SUBJECT: ISSUANCE OF AMENDMENT ON SNUBBER SURVEILLANCE (TAC NO. 75302)

AMENDMENT NO. 19 TO FACILITY OPERATING LICENSE NO. NPF-69 NINE MILE POINT
NUCLEAR STATION UNIT 2

SAFETY EVALUATION BY THE OFFICE OF NUCLEAR REACTOR REGULATION
RELATED TO AMENDMENT NO. 19 TO FACILITY OPERATING LICENSE NO. NPF-69
NIAGARA MOHAWK POWER CORPORATION
NINE MILE POINT NUCLEAR POWER STATION, UNIT NO. 2
DOCKET NO. 50-410

Figure 4.7.5-1 Sample Plan 2 for Snubber Functional Test

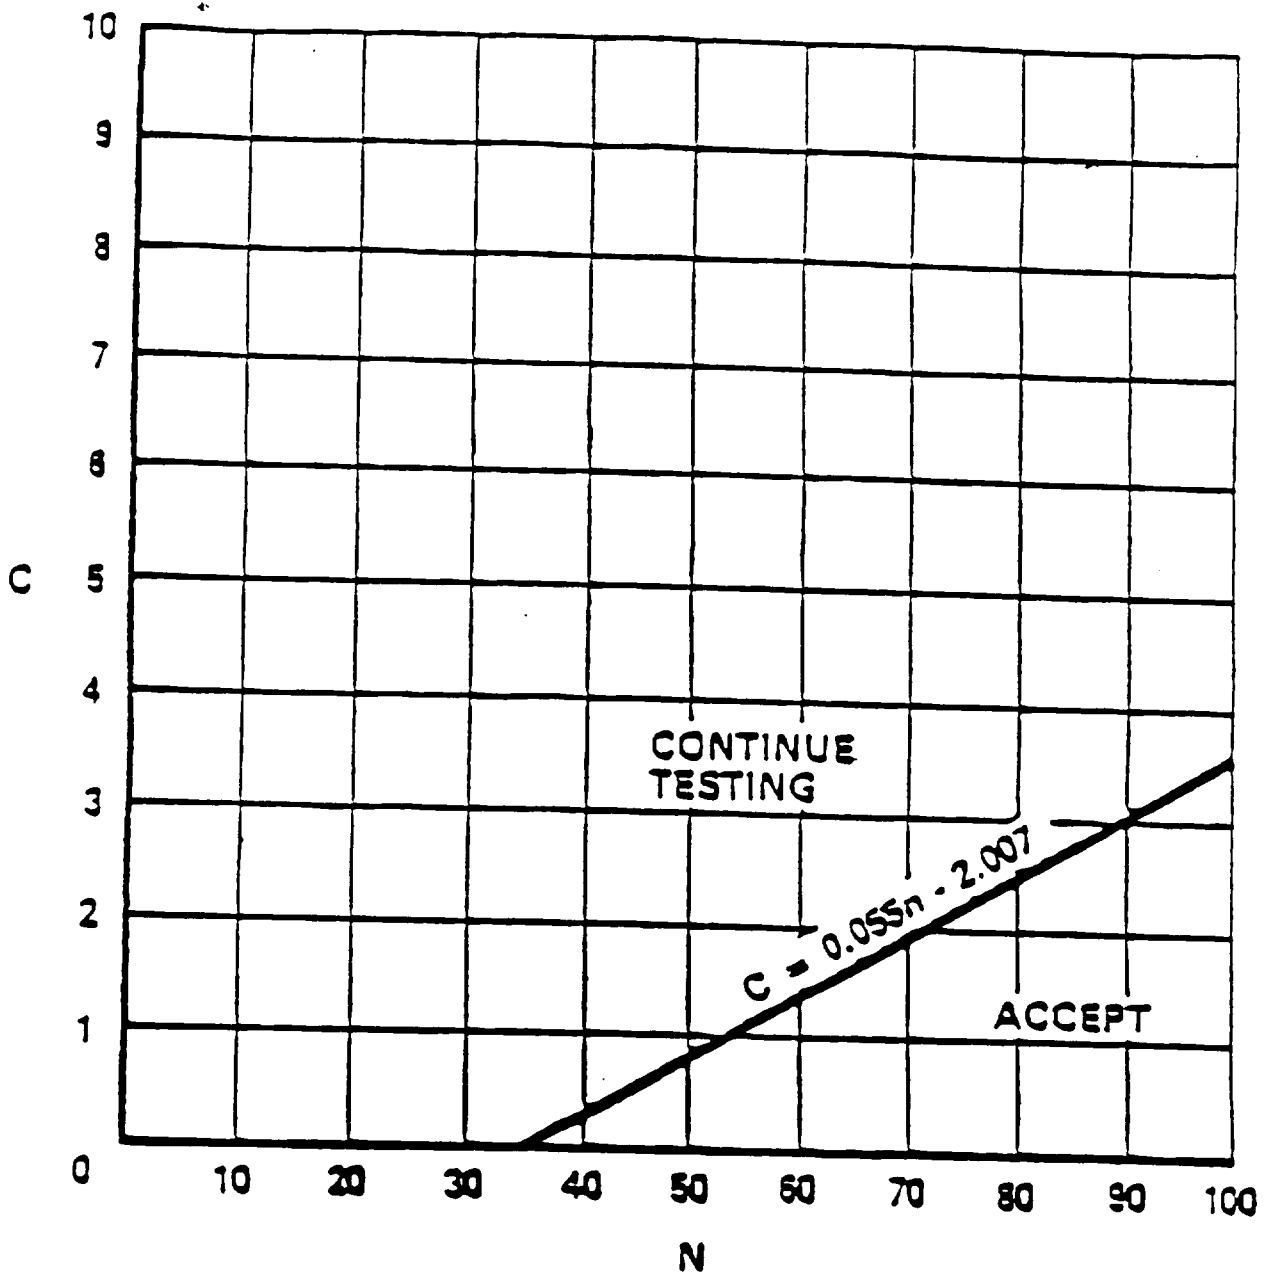
The second sampling plan, the "37 plan," described in Specification 4.7.5.e(2) requires that a representative sample of snubbers be tested periodically in accordance with Figure 4.7.5-1. Figure 4.7.5-1 provides the acceptance criteria method for the functional test results and denotes a "reject" region and a "continue testing" region. If at any time the plotted test results fall within this "reject" region, then all snubbers are to be functionally tested. The proposed change revises surveillance requirement Specification 4.7.5.e(2) and Figure 4.7.5-1 to delete the "reject" region and substitute an expanded "continue testing" region.

With the deletion of the "reject" line, plotting of results by lot or individual basis becomes a moot point because snubbers must continue to be tested until the point falls into the "accept" region or until all snubbers have been tested.

Figure 4.7.5-1 as it appears in the technical specification was developed using "Wald's Sequential Probability Ratio Plan." Statistical studies using Wald's sequential sampling plan indicate that a major change in the reject line caused an insignificant change in the accept line or, in other words, acceptance is independent of rejection. These studies also demonstrate that while the probability of false acceptance of a bad snubber population under the proposed amendment still exists, it is negligible. As long as the "reject" line remains in the sample plan there is some possibility of rejecting a good snubber population and consequently requiring an unnecessary 100% functional testing of snubbers with attendant ALARA and safety concerns, manpower utilization and outage extension. The proposed technical specification change will alleviate these problems and still ensure continued or additional testing if snubber quality of failed snubbers is equal to or greater than 5%. These changes have been previously evaluated by the NRC through ANSI/ASME OMc-1990, Part 4, participation and by granting similar technical specification changes.

2. An initial representative sample of 37 snubbers of each type shall be functionally tested in accordance with Figure 4.7.5-1. "C" is the total number of snubbers found not meeting the acceptance requirements of Specification 4.7.5.f. The cumulative number of snubbers of a type tested is denoted by "N". If at any time the point plotted falls in the "Accept" region, testing of snubbers may be terminated. When the point plotted lies in the "Continue Testing" region, additional snubbers shall be tested until the point falls in the "Accept" region or all the snubbers of that type have been tested.
